RE: Tentative Waste Discharge Requirements (WDRs)
Kern County Public Works Department Comments
Arvin Sanitary Landfill
Kern County, California
WDID No. 5D150303001

Arvin Sanitary Landfill – Tentative Waste Discharge Requirements (WDRs)

Kern County Public Works Department (Department) Summary of Comments

Arvin Sanitary Landfill

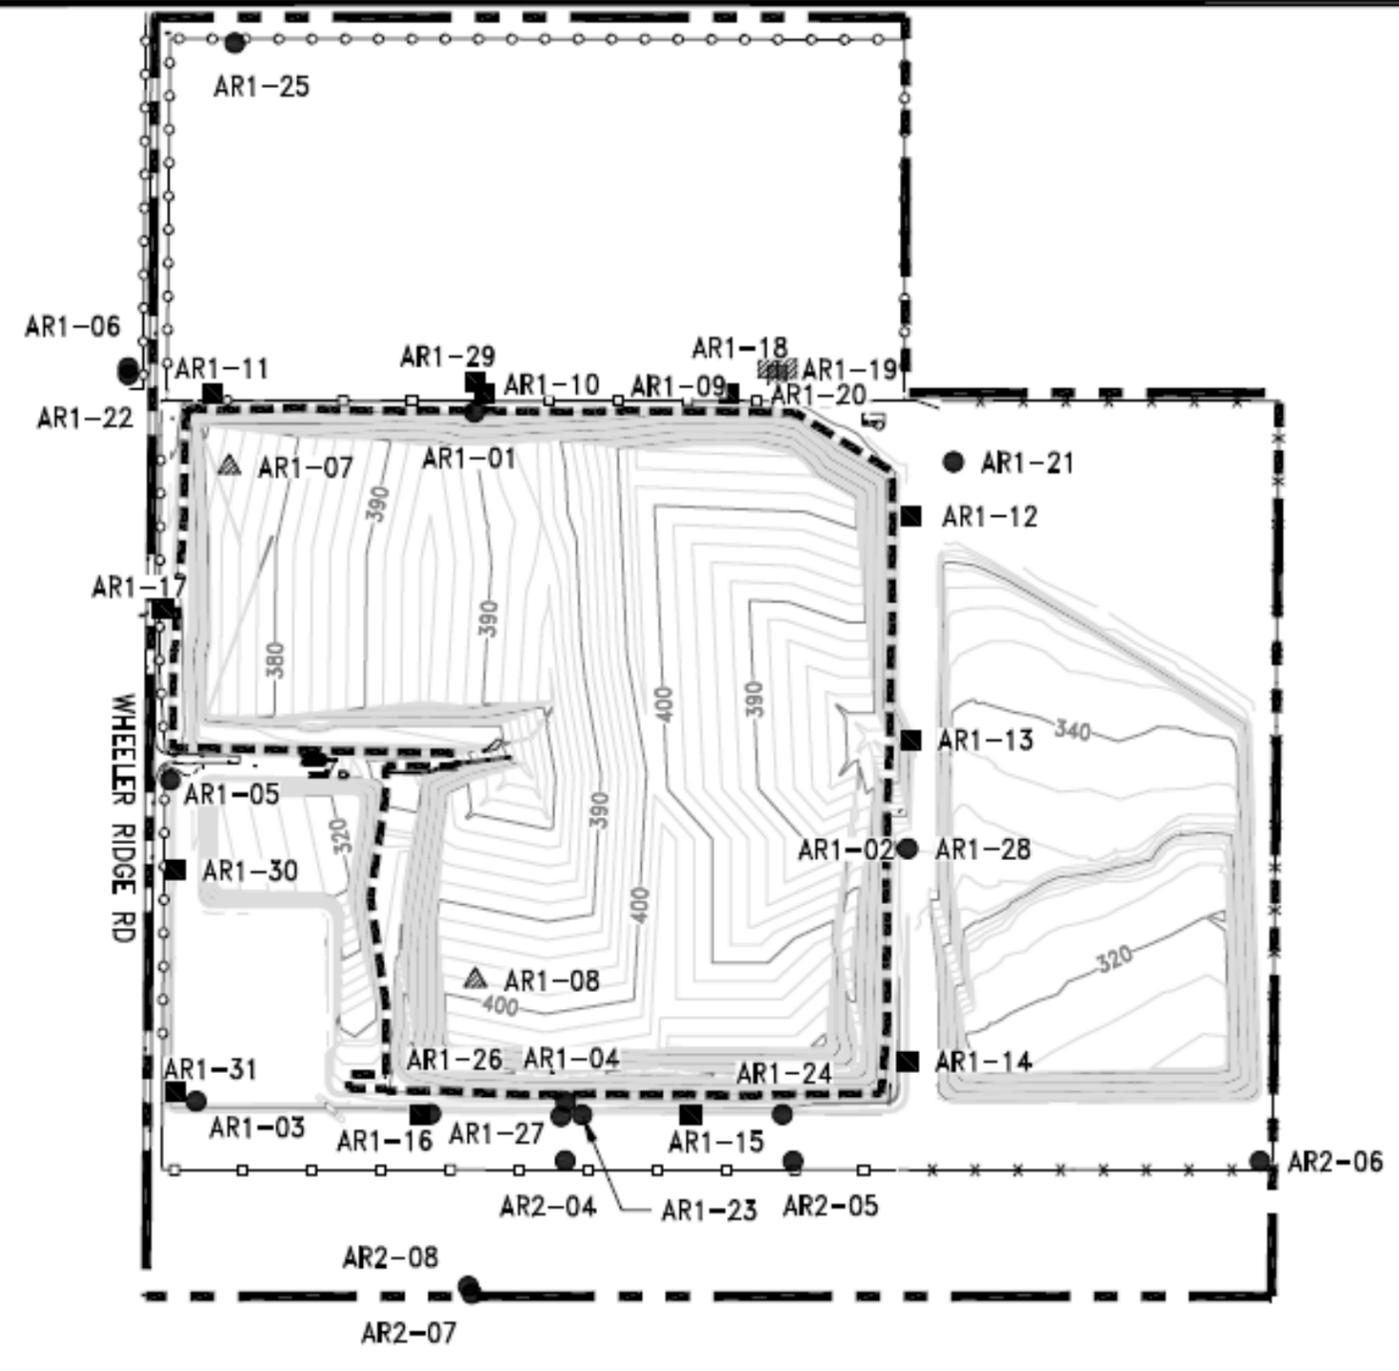
The property boundary is incorrect. Please see the attached Arvin Sanitary Landfill property boundary maps.

Property boundary is incorrect. Please see the attached Arvin Sanitary Landfill property boundary maps. Also, the VenVirotek note should perhaps say “Former VenVirotek Area”.
